GS-15013

General Supplemental Specifications for Highway and Bridge Construction

Effective Date
October 19, 2021

THE STANDARD SPECIFICATIONS, SERIES 2015, ARE AMENDED BY THE FOLLOWING MODIFICATIONS, ADDITIONS, AND DELETIONS. THESE ARE GENERAL SUPPLEMENTAL SPECIFICATIONS AND SHALL PREVAIL OVER THOSE PUBLISHED IN THE STANDARD SPECIFICATIONS.

Figure 4137.01-01: AASHTO T 350 Test Temperature by County (°C)

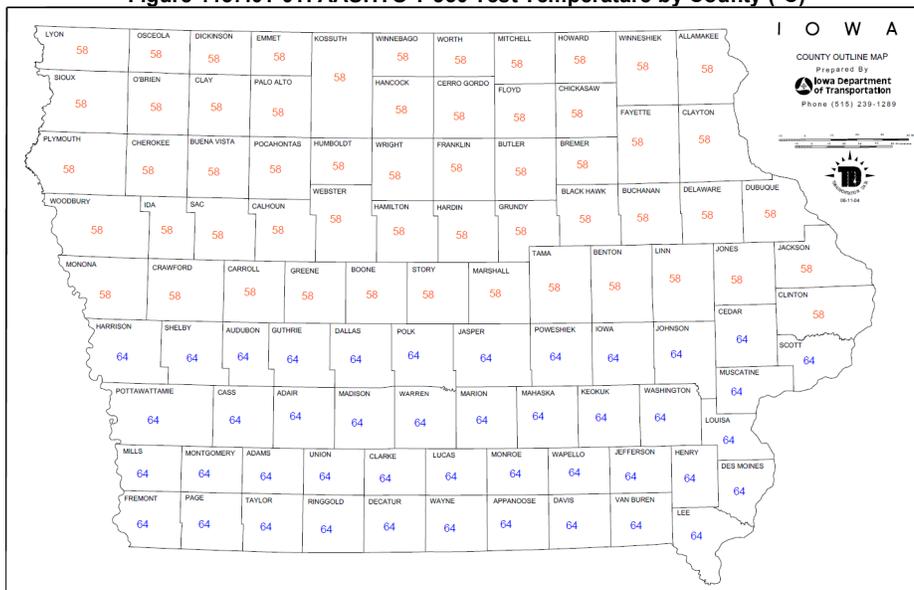
(Delete figure)
